Access Compliance Report

Public Rights-of-Way

Intersection ID: 48569	Main Street: RED_SQUIRREL_TL	Cross Street: SALAMANDER_RUN_LN	Location: NE
ADA ID: D6A07566B1AD	Ramp Type: Perp	Initial Pass/Fail: Pass	Overall Compliance: No
Severity Score: 0			
Codes/Mitigation Info/Possible Solution		Field Measurements/Component Compliance

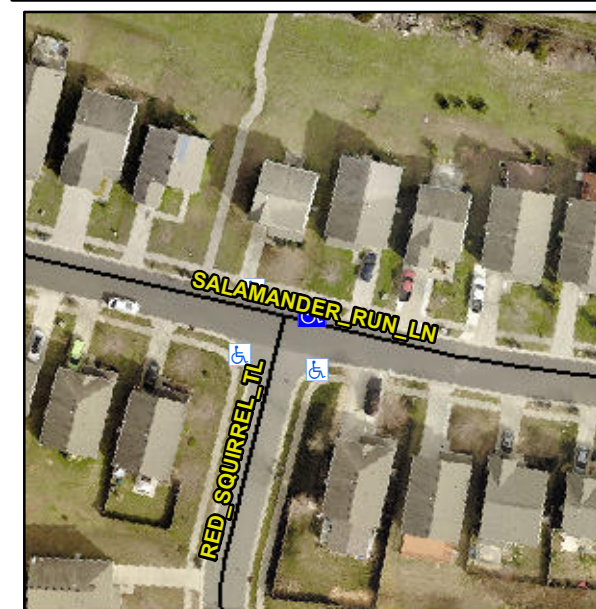
Not Found, R304.2.2-Perp, R304.3.2-Para, R304.5.3, R305.2

Compliance	Description	Data	Compliance	Description	Data
N/A	Ramp Length (in)	53.5	Yes	Ramp Slope (%)	6.1
Yes	Ramp Width (in)	48.0	Yes	Ramp XSlope (%)	1.6
N/A	Flare Type LT	Sloped	N/A	Flare Type RT	N/A
N/A	Flare Slope LT (%)	2.1	N/A	Flare Slope RT (%)	1.4
N/A	Flare Traversable LT?	No	N/A	Flare Traversable RT?	No
Yes	Landing Length (in)	48.5	Yes	DWS Provided?	Yes
Yes	Landing Width (in)	48.0	Yes	DWS Contrast?	Yes
No	Landing Slope (%)	2.9	Yes	DWS Length (in)	24.5
No	Landing X Slope (%)	2.6	Yes	DWS Full Width?	Yes
N/A	Landing Curb? (Y/N)	No	No	DWS Offset (in)	2.5
N/A	Shared Landing?	No			
Yes	Gutter Ponding?	No	Yes	Gutter Slope (%)	2.2
Yes	Gutter Lip Ht (in)	0.0	Yes	Gutter X Slope (%)	1.8
N/A	Painted X Walk1?	No	N/A	Painted X Walk2?	N/A
	X Walk 1 Direction	To S		X Walk 2 Direction	N/A
N/A	X Walk 1 Width (in)	N/A	N/A	X Walk 2 Width (in)	N/A
	X Walk 1 Slope (%)	2.9		X Walk 2 Slope (%)	N/A
	X Walk 1 X Slope (%)	1.5		X Walk 2 X Slope (%)	N/A

N/A	Ramp inside XWalk1?	N/A	N/A	Ramp inside XWalk2?	N/A
	Road Slope (%)	N/A	N/A	Clear Space?	Yes
	Road X Slope (%)	N/A	N/A	Clear Space to XWalk (in)	N/A
Yes	Any Obstructions?	No	Yes	Storm Grate/Utility Hazard?	No
	Obstruction Type			Storm Grate/Utility Type	
		N/A			N/A
			Yes	Surface Condition? (G/P)	Good

Remove & Replace Entire Ramp.
